Ward: Whitefield + Unsworth - Unsworth Item 04

**Location:** 23 Hillsborough Drive, Bury, BL9 8LE

**Proposal:** Change of house type to include rear dormer extension

**Application Ref:** 66928/Full **Target Date:** 24/06/2021

Proposed Site Plan

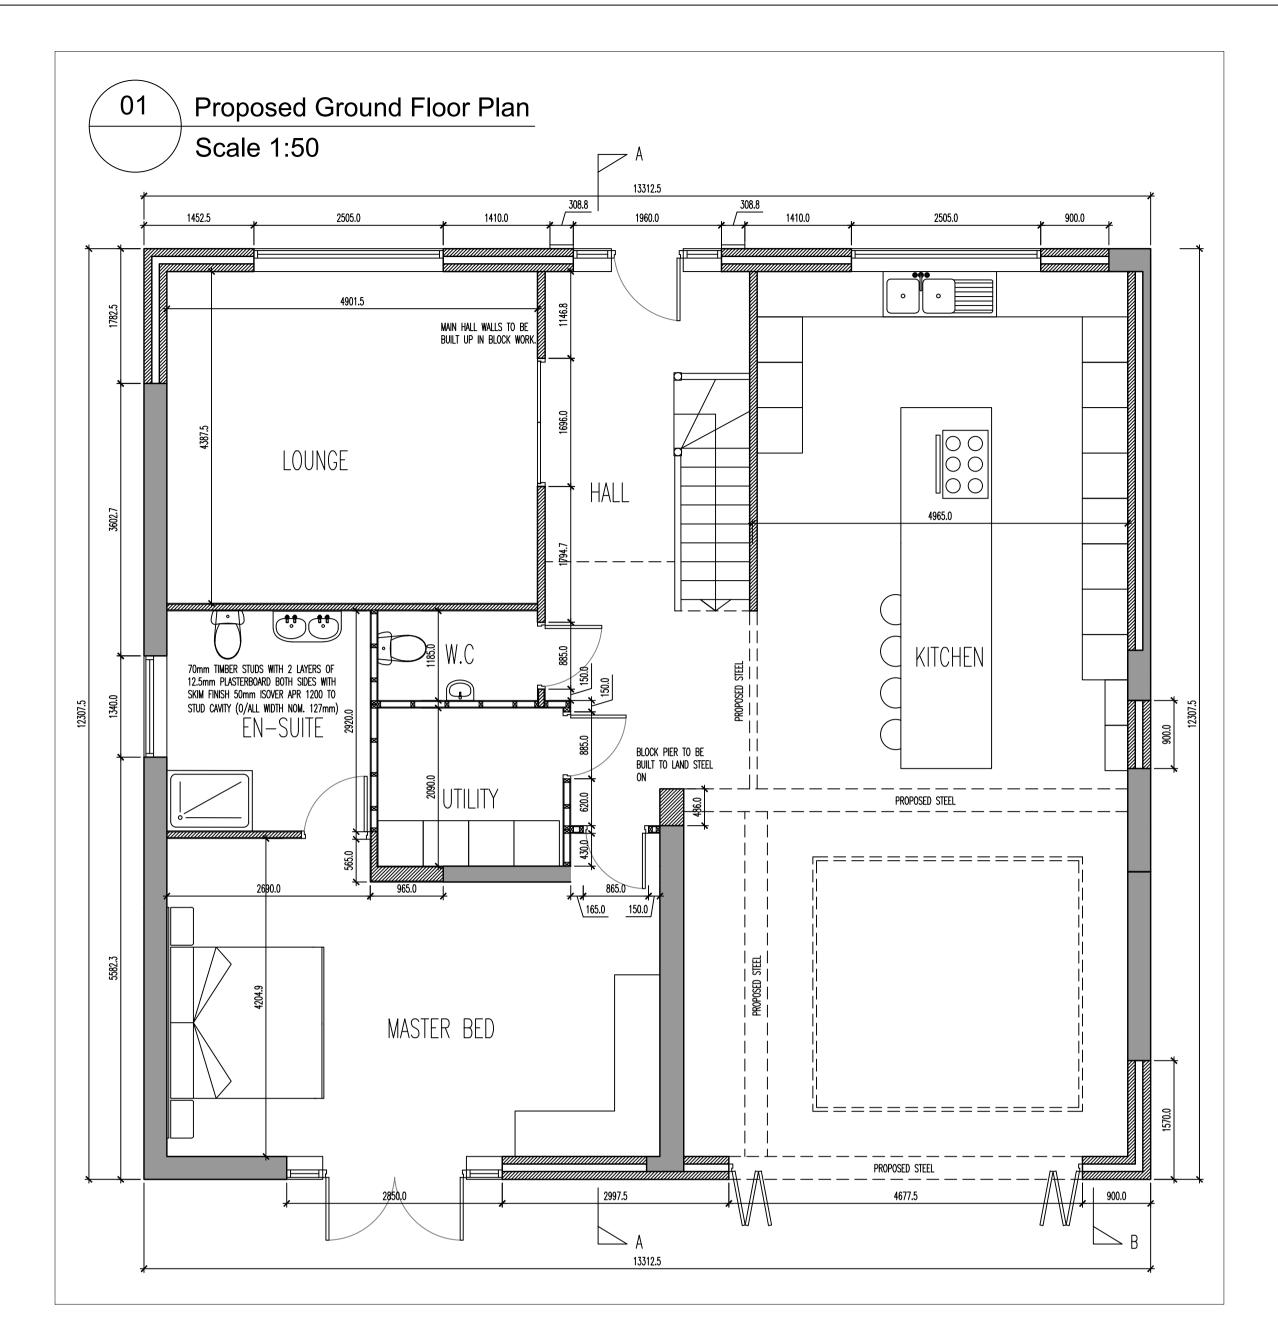
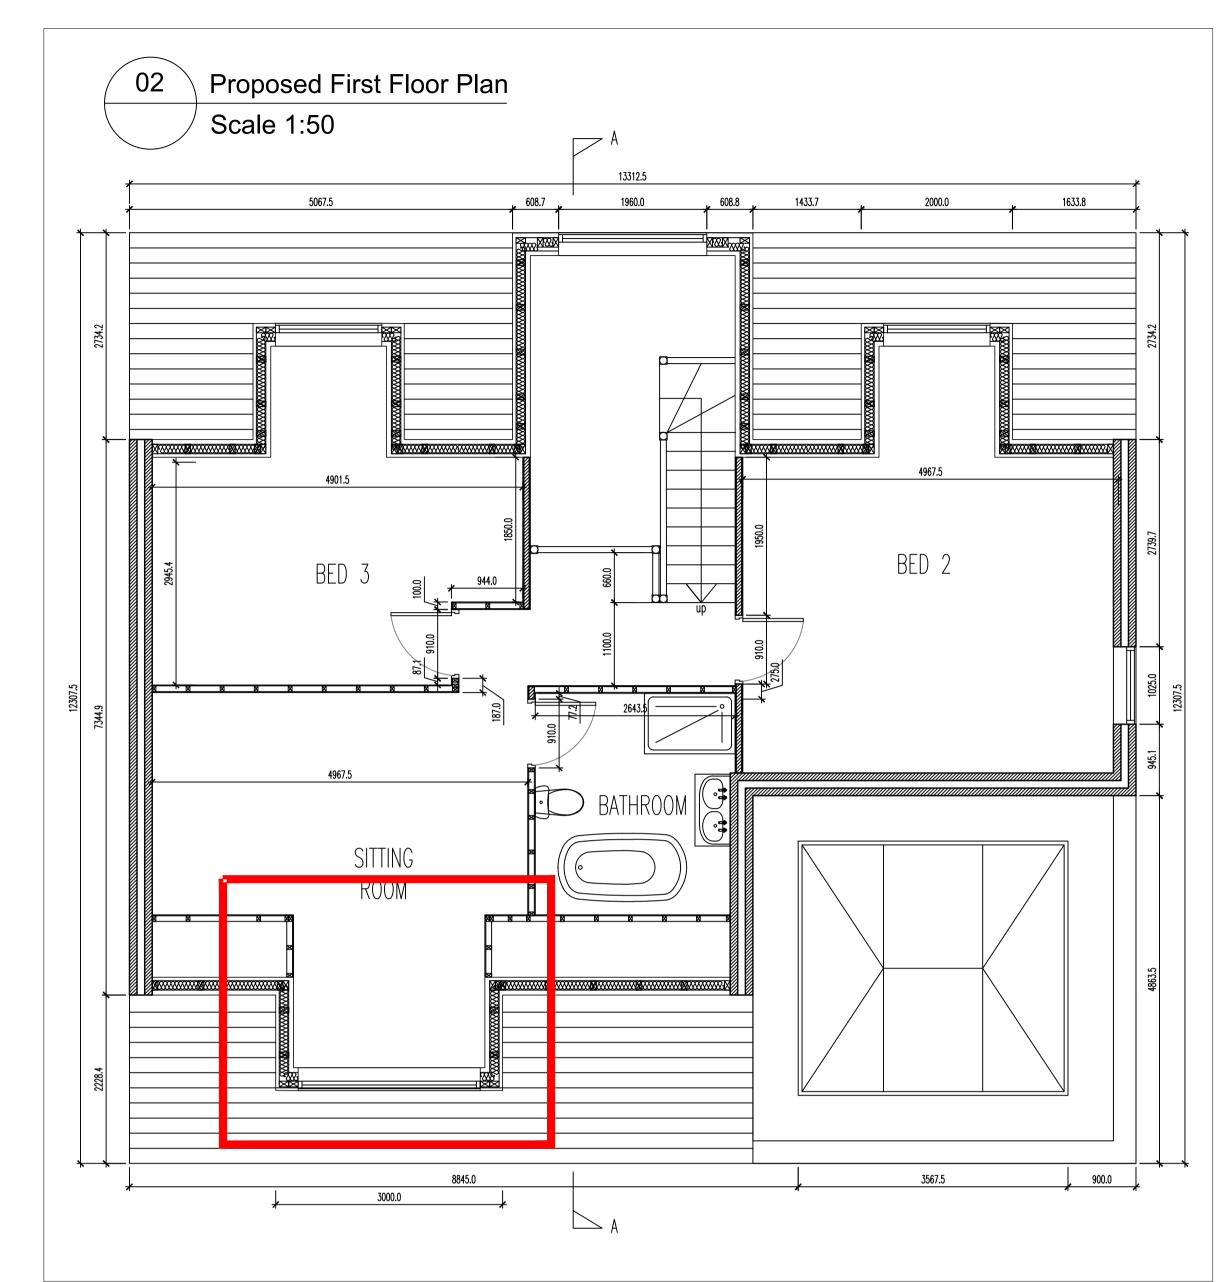
The development proposes 2 parking spaces located to the existing front drive and would be as previously approved. SPD11 - Parking Standards requires a maximum of a 3 spaces for a 3 bed dwelling (same for a 4 bed dwelling) and 2 spaces can be acceptable for high access areas. The site is located in a relatively high access area and with on street parking running the length of the fairly wide road. In this respect the 2 parking spaces proposed are considered sufficient.

- 3. The car parking arrangements indicated on approved plan reference ZT18-196-03 Revision E, incorporating the retention of the existing dropped crossing, provision of a driveway to the dimensions indicated, in a porous/permeable material and/or measures to prevent the discharge of surface water onto the adopted highway, fencing to prohibit the use of the existing informal parking area adjacent to Leeds Close and all associated footway remedial works abutting the site required as a result of the construction of the proposed development and statutory undertakers connections to the dwelling, shall be implemented to the satisfaction of the Local Planning Authority prior to the dwelling and driveway hereby approved being occupied/brought into use.

Drawing
Proposed Floor Plans

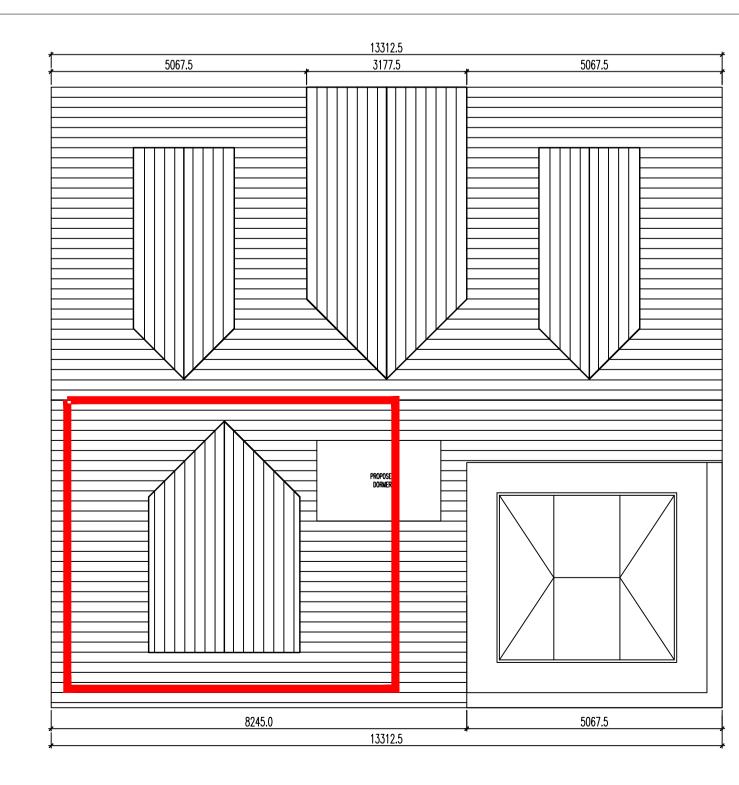
This application seeks to amend a part of the approved design. The proposal would follow the footprint and height of the previously approved dwelling. The change involves the addition of a 3m wide dormer to the rear roof slope to form a sitting room and the room formerly noted as a store to the first floor at the front, would now be a bedroom.

The additional dormer as part of this proposal would be to a habitable room. It would be set 1.6m in from the boundary with No.25 to the side and the window would face directly down the site garden. There would be in excess of 7m to the rear boundary and the properties at the rear would be over 20m away and therefore policy compliant and not cause unde impact upon privacy.

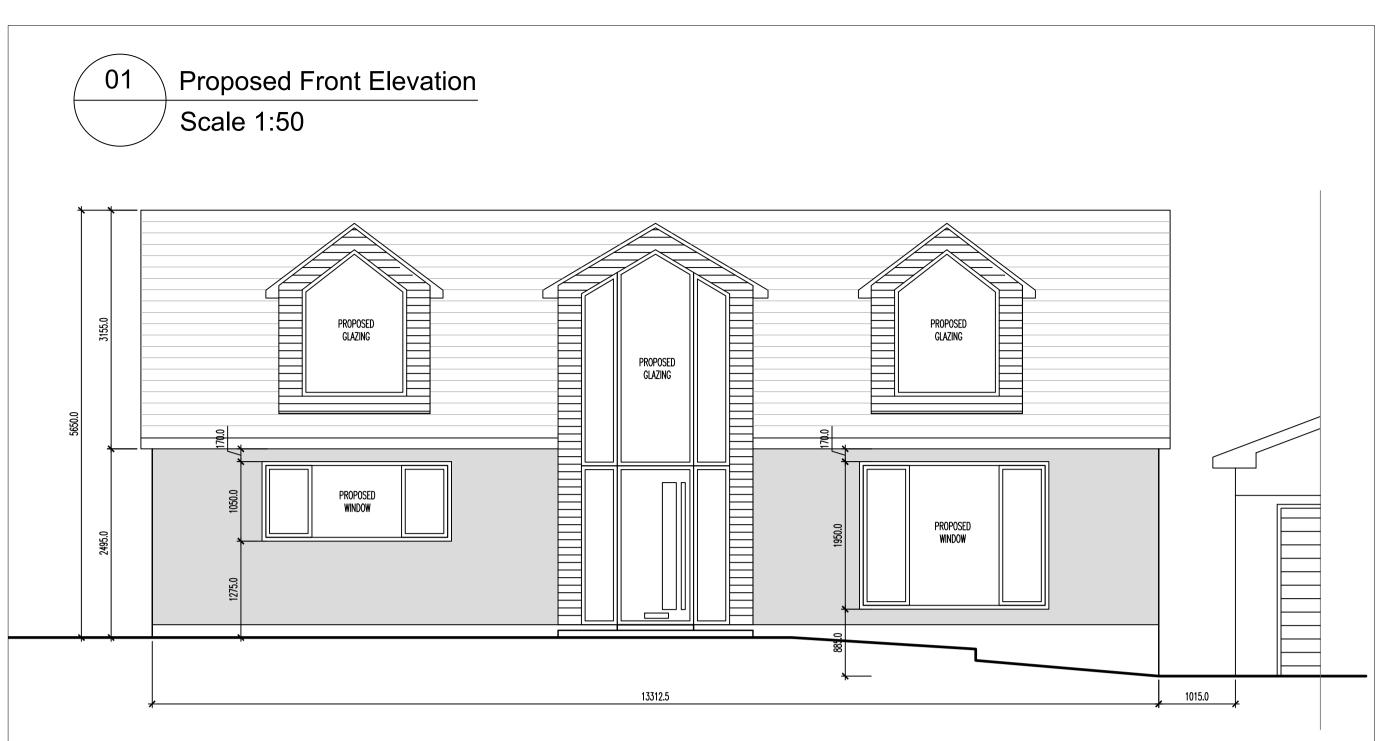
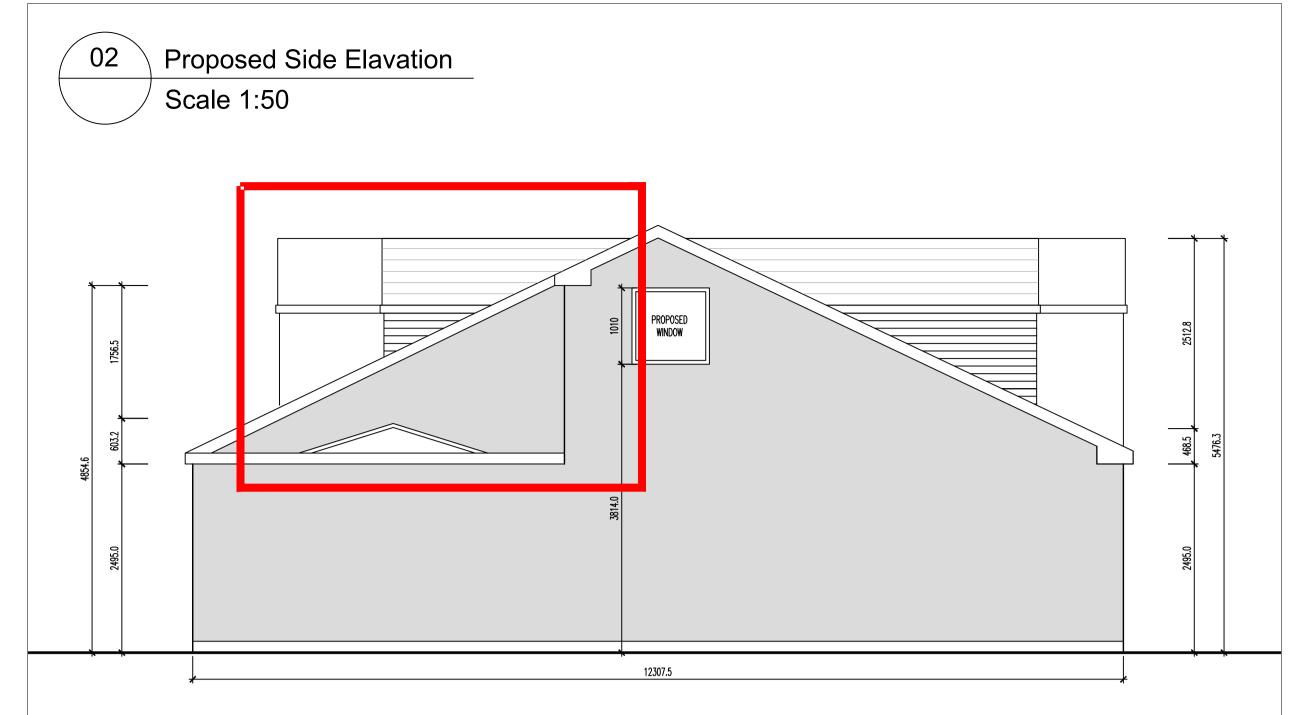
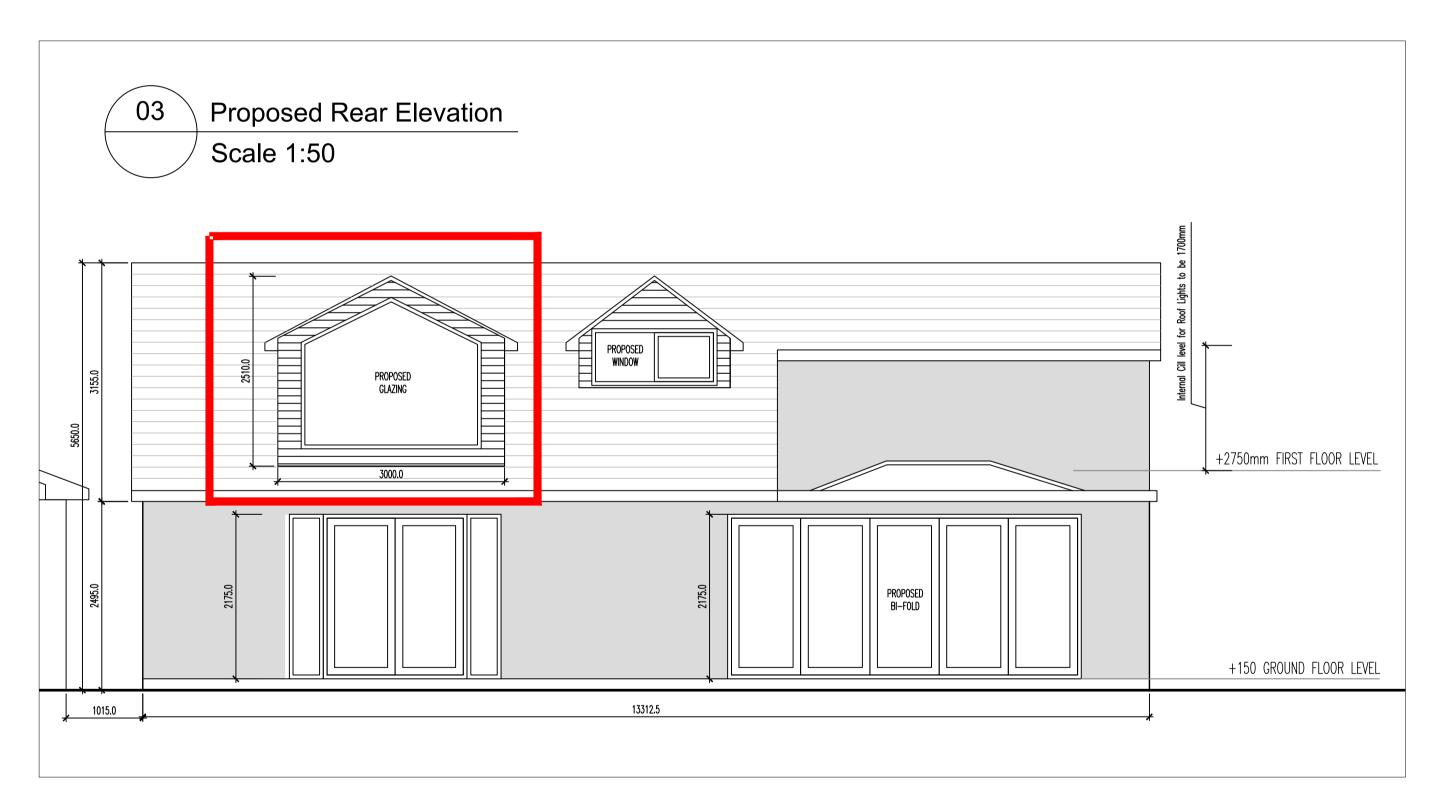
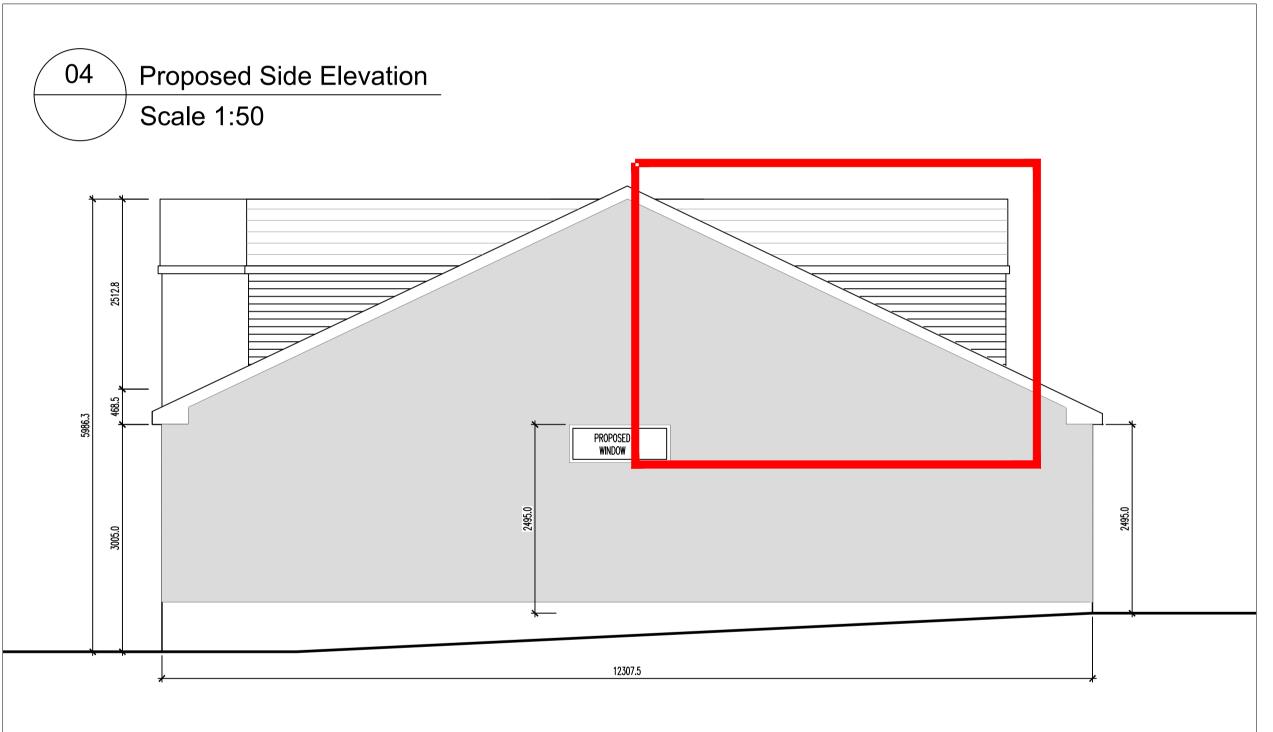
The amended design would still be a dormer bungalow with eaves to the same height as the original bungalow and the ridge 1.8m higher as already approved. The front roof slope would have two pitched roof dormers each side of a central dormer that would extend to two storey as the entrance and landing. This remains unchanged.

The proposal would be as previously approved with the only external alteration being the addition of a rear dormer. It would have a pitched roof and be 3m wide with a full glazed window. It not occupy a disproportionate area of the rear roof slope and be centrally located above patio doors to the rear elevation. Given where the dormer would be located, it would be set away from the public street side of the property and would not have a dominant or ready appearance in the street scene. As such this change would not cause any significant concerns in relation to visual amenity or design.
